SHIRE OF PEPPERMINT GROVE

Special Council Meeting

8.1.2 12 The Esplanade – Works Ancillary to a Single House (Siteworks, Retaining Walls and Fencing)

Voting Requirement	:	Simple Majority
Location / Property Index	:	12 The Esplanade, Peppermint Grove
Application Number	:	DA2022/00029
LPS No 4 Zoning	:	Residential R10
Land Use	:	Single House
Lot Area	:	1597m ²
Disclosure of any Interest	:	Nil.
Previous Items	:	Item 8.1.1, 28 February 2023 Item 8.1.4, 23 August 2022 Item 7.1, 10 December 2019 Item 8.1.3, 23 July 2019
Applicant	:	Planning Solutions
Owner	:	Theresa Lynn Smith
Assessing Officer	:	Mr J Gajic
Authorising Officer	:	Mr J. Gajic

SITE PLAN -
Proposed Site Works
DRAWING

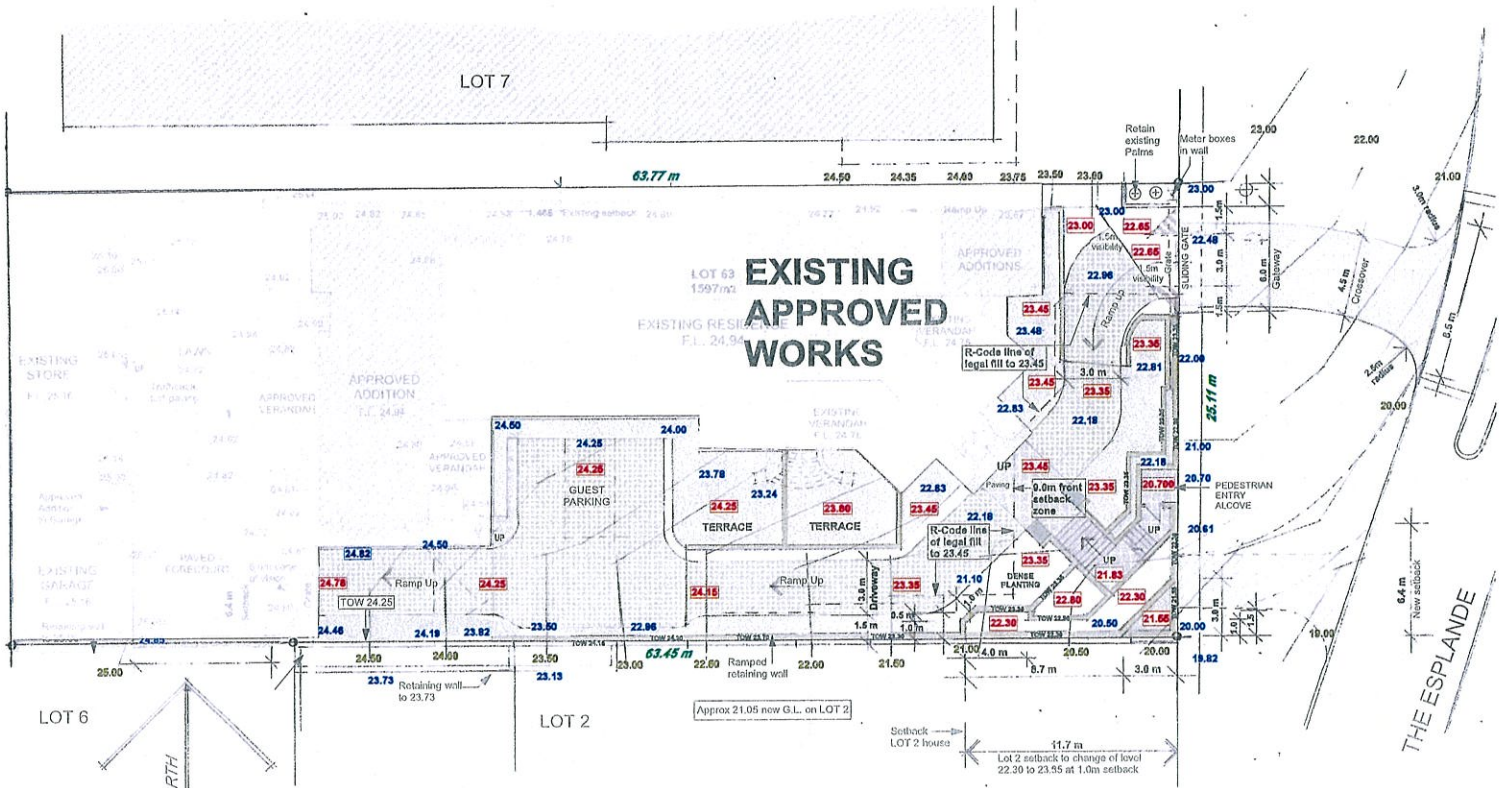
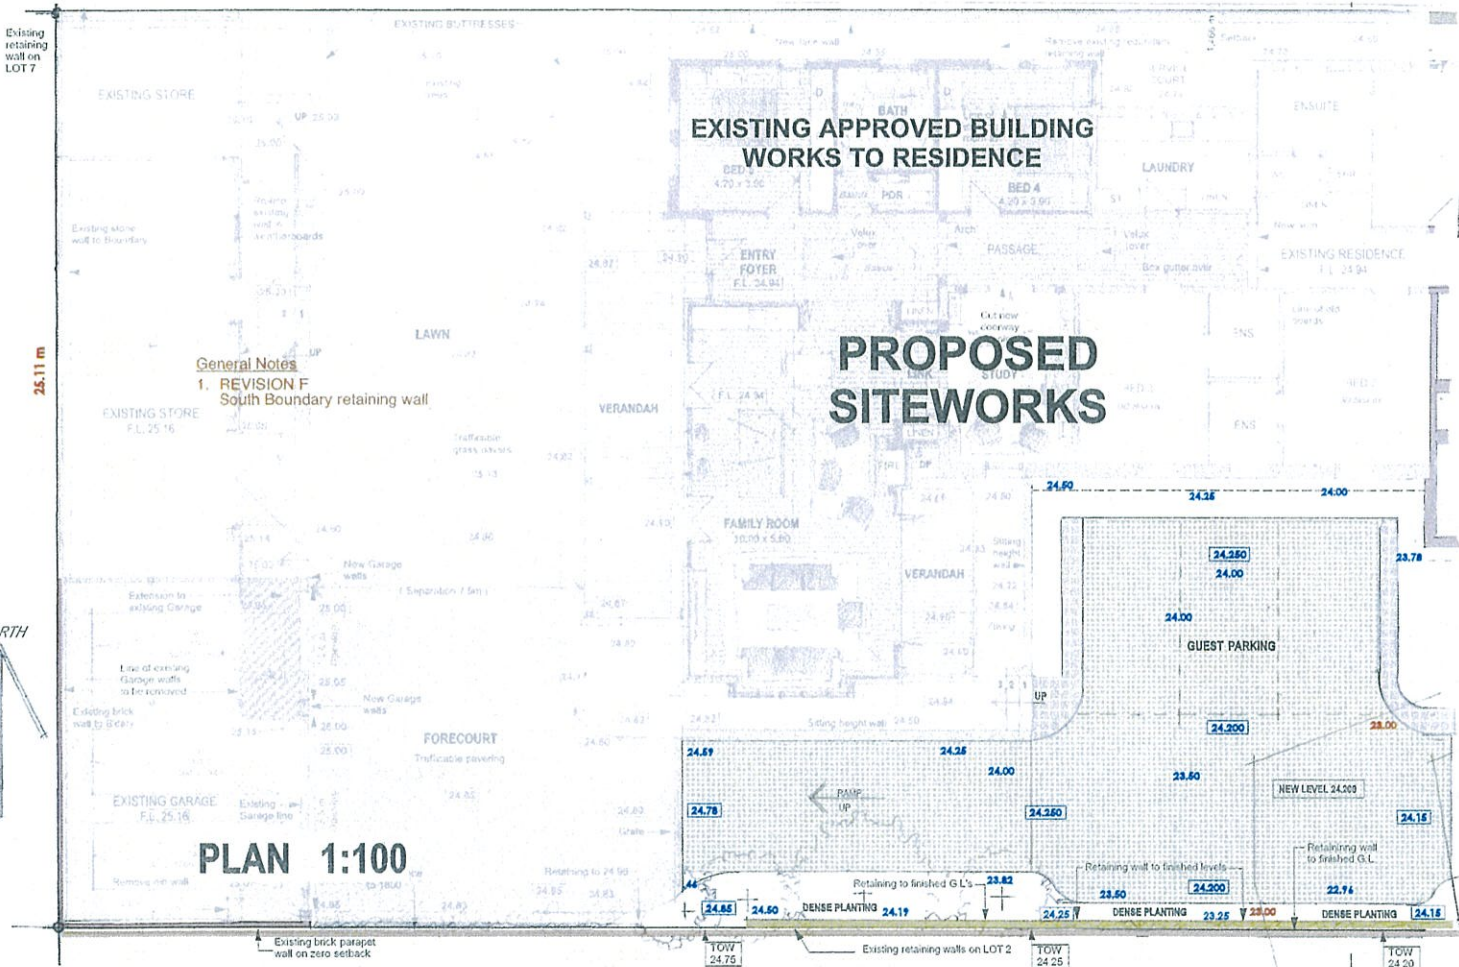
The extent of fill has been reduced generally to the southeast corner of the site. The second terrace at the 22.30m level has been extended along the southern boundary and subsequently widened 500mm following the second Mediation Session. This has resulted in fill along the southern boundary 6m to 12m from The Esplanade being reduced by 1050mm. A fourth terrace has additionally been introduced at the 22.80m level adjacent to the pedestrian path landing. This has resulted in a 550mm reduction of fill and further stepping of the forecourt from the southern boundary.

- (ii) Spray drift must be contained within the subject site.
 - (iii) Dividing fencing shall not be erected where indicated by red ink on the endorsed site plan without the prior written consent of the CEO.

1. Prior to this permit having force or effect amended plans generally in accordance with the submitted plans submitted on 21 and 27 July 2023 shall be submitted to the satisfaction of the CEO and endorsed. The amended plans shall have further regard to the following:
 - (i) The extent of the driveway and associated terrace at the 23.35m and 23.45m levels hatched with red ink on plans modified by the Shire shall be lowered to no greater than the 22.75m level.
 - (ii) A physical barrier (such as a non-mountable kerb) shall be installed along the south side of the driveway to delineate and prevent access into the adjacent landscaping.

EAST ELEVATION 1:100
Current Proposed Streetscape
with Previously Approved Levels Overlay

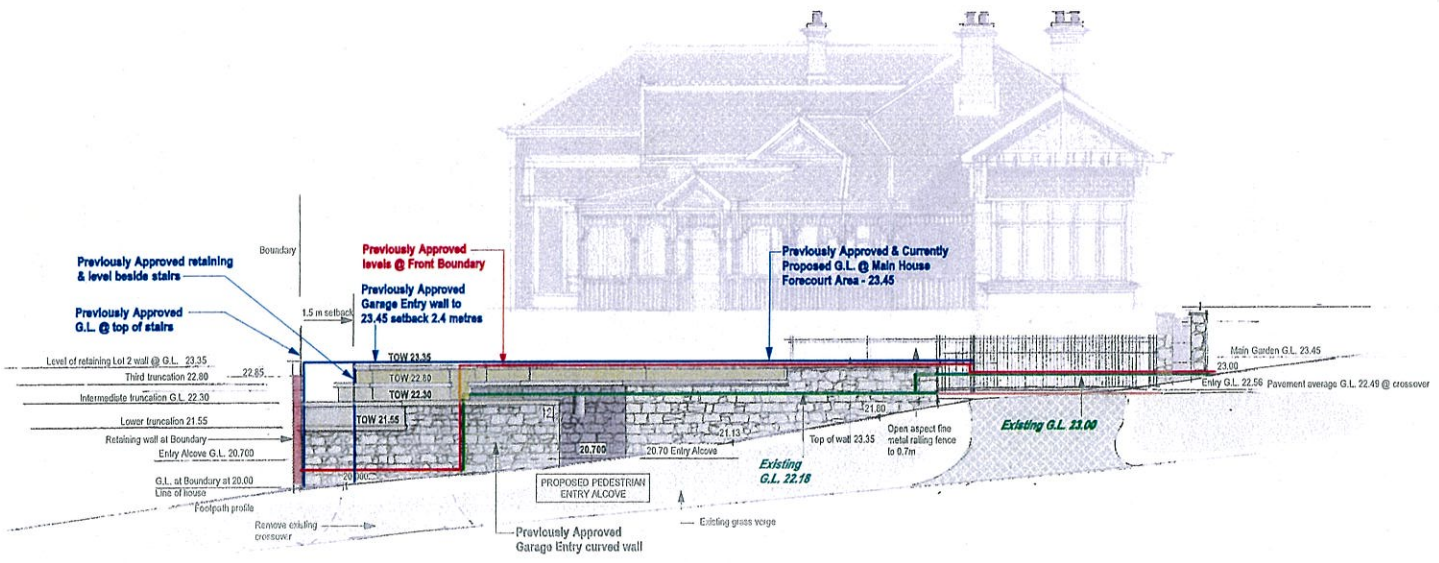
The street wall has been reduced in height to not exceed 2.1m above the natural ground level and the 90 per cent open aspect steel railing fencing above reduced to a height of 700mm for that extent to which the sliding access gate will be positioned when open. The resultant combined wall and fence height now varies between 1.9m to 2.7m above the natural ground level. The access gate and open aspect railing fencing is consistent in appearance and materials and will provide a contrast to the street wall stonework. The street wall, access gate and open aspect railing fencing has been assessed to satisfy the applicable design principles contained in the R-Codes, and the planning policy framework.

STEWARTS BOUNDARY
WITH COUNCIL CONDITION TO PROP
ARRIVAL BY 600 M.

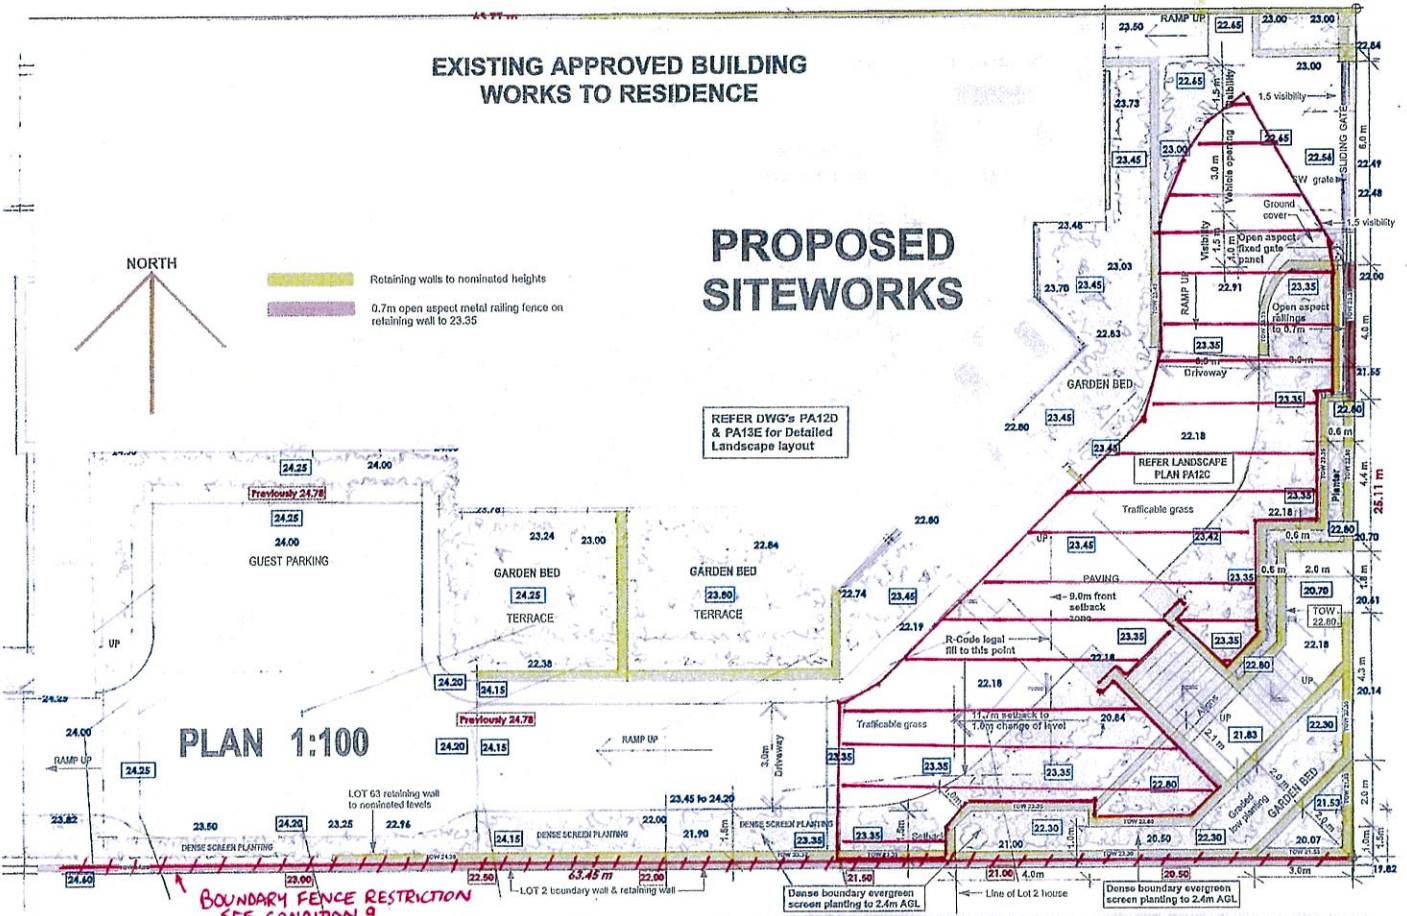
RAMP GRADED FROM NEW ARRIVAL LEVEL
TO WHERE IT MEETS OLD RAMP. (3° GRADE)
2 CARPARKS ON RAMP
3° CROSS FELL
